## Modified fog and spotlamp unit

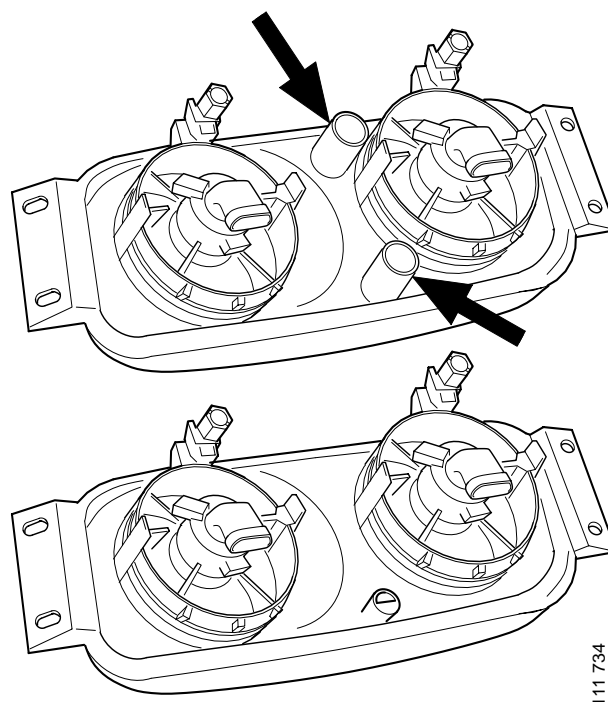
Trouble has been caused by dust and moisture entering the fog and spotlamp unit. The dust and moisture have entered via the two valves at the rear of the unit.

Scania has developed a modified fog and spotlamp unit on which the valves have been removed and all ventilation is effected instead via the bulb holders.

Plugs for mounting over the ventilation holes have been developed as a service solution for existing fog and spotlamp units. These plugs will not be fitted on production fog and spotlamp units.

*The upper illustration shows the old fog and spotlamp unit with valves.*

*The lower illustration shows the new fog and spotlamp unit without valves.*
